FIRE SAFETY INSPECTION REPORT

EVITEX APPARELS LIMITED
SHIRIR CHALA, BHABANIPUR

ACCORD
on Fire and Building Safety in Bangladesh

July 8, 2014

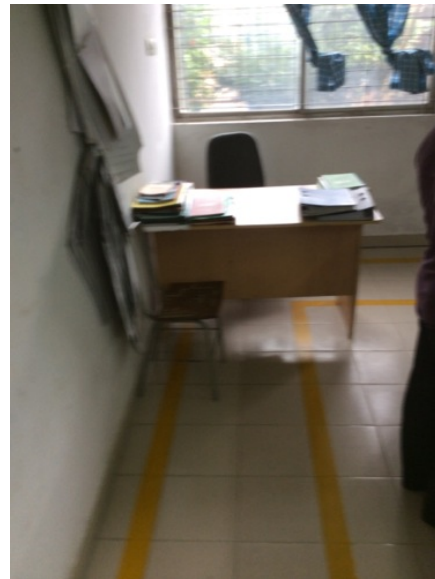
F-7	Egress	Storage was located in the exit stair. Location: In two of the stairwells North and east stairwells both had storage in them.	Remove all storage from exit stairs and egress paths.	Immediate
-----	--------	--	---	-----------
